**Re: SSDA 10431 Moorebank Precinct West Stage 3 - IPC Public Meeting:
Response to IPC Questions Raised**

We are writing on behalf of the applicant (SIMTA) regarding State significant development application (SSDA) 10431 Moorebank Precinct West Stage 3 (MPW 3) in response to matters raised in an email from the IPC (Bradley James; 21 April 2021) to Richard Johnson (Aspect Environmental), being:

Additional Information Request MPW Stage 2 SSD 7709 Re: Importation of Fill

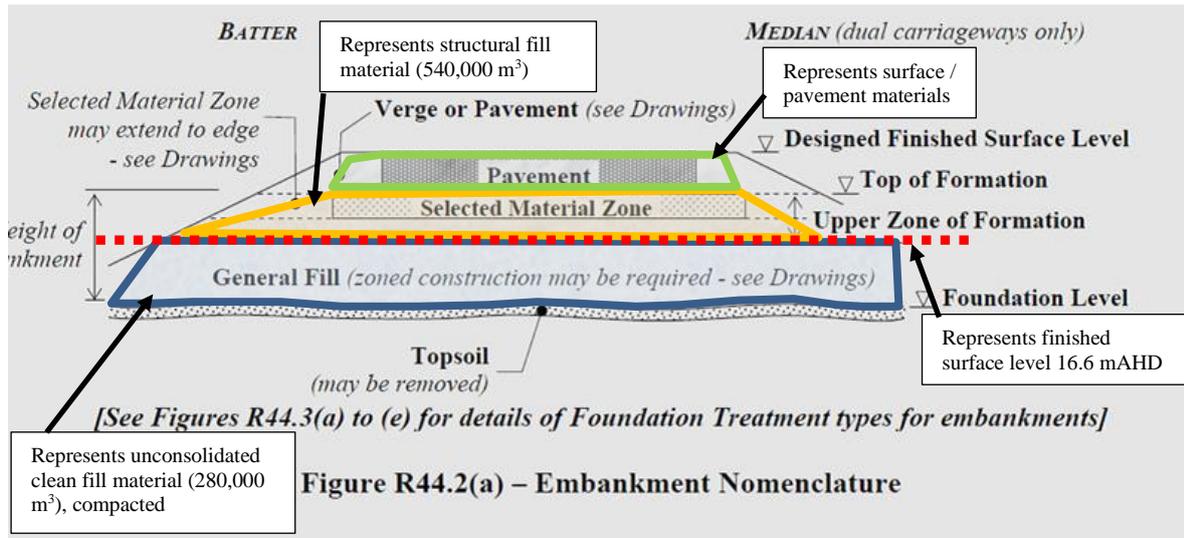
1. Does the 16.6m AHD level include structural and/or uncompacted fill? Applicant to reissue note.
2. Applicant to review importation of fill across the development and comment on a potential condition reducing maximum importation of fill from 22,000m³ to a level closer to the maximum reached to date – bearing in mind that Stage2 / Stage 3 overlap is now less likely (see recommended condition A8).
3. Question from Site Inspection – Applicant to comment on the potential penetration of PFAS by tree roots. Applicant to comment on how this would be managed.

1. Clarification of proposed finished surface level of 16.6 mAHD

clarifies the calculation of unconsolidated / structural fill material to provide context to the finished surface levels, and includes Figure R44.2(a) from RMS' Guide to QA Specification R44 Earthworks. This figure has been extracted from the correspondence and is provided below as an annotated representation to demonstrate the application of clean and engineered fill, and surface/pavement materials for MPW Stage 3.

Unconsolidated clean fill material (i.e. virgin excavated natural material (VENM) and excavated natural material (ENM)) (280,000 m³) will be placed on the site and compacted to achieve the final ground levels upon which the formation elements of the development are placed. This is generally represented by the 'General Fill' element of the diagram. Structural fill material (540,000 m³) will be placed over the compacted clean fill material to provide a geotechnically suitable pad for structural elements, including warehouses. Surface or pavement materials will provide the finished surface levels for stormwater, and levels from which the building height will be calculated.

The finished surface level of the filled sections of the site at 16.6 m AHD (per SSD 5066 MOD 1 Condition of Consent (CoC B19)) is represented by the dotted red line, as shown in the figure above.

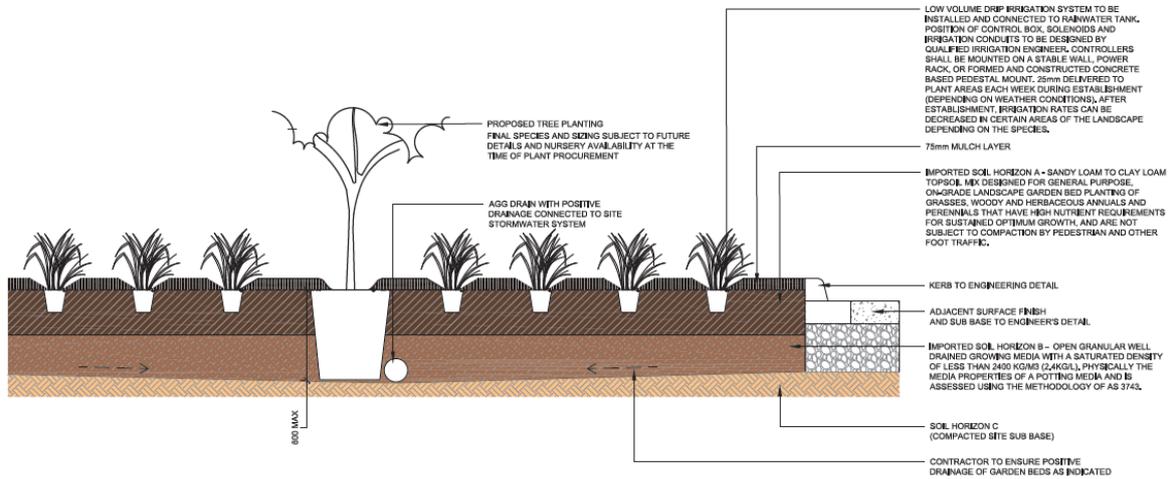
3. Potential penetration of PFAS by tree roots

Roots of trees located within the MPW developable site would be very unlikely to penetrate potential per- and polyfluoroalkyl substances (PFAS) impacted areas, as:

- A fill zone of approximately 3.6 m generally overlays any potential remaining PFAS impacted site soils.
- Trees will be planted according to NATSPEC specifications, within individual holes excavated within imported soil horizon B (open granular well drained media). Given the excavated holes will be located above the soil horizon C, it is highly unlikely that tree roots would extend to a great depth into this highly compacted sub base material (refer to figure below). (Source: Urban Design Development Report, July 2020; Sheet PIWW-GNK-LN-DWG-400).

Figure 1: Figure R44.2(a) from RMS' Guide to QA Specification R44 Earthworks

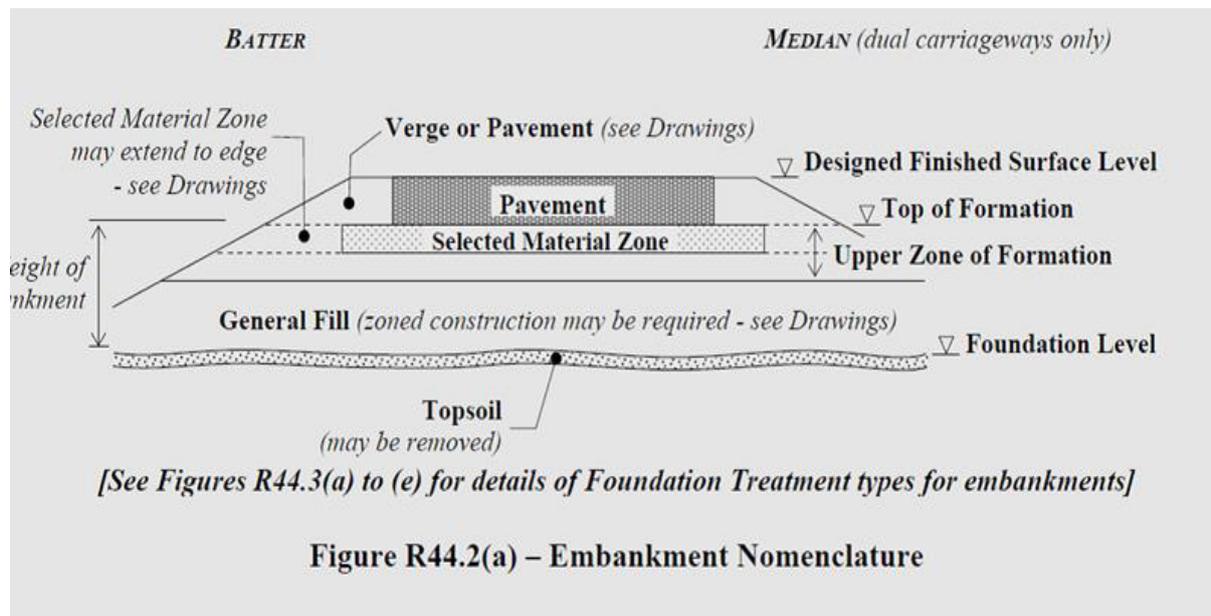
For clarity, the consideration of application of clean fill for bulk earthworks and engineered fill and ballast or other surface/pavement materials, is demonstrated schematically in the below figure from RMS' *Guide to QA Specification R44 Earthworks*.
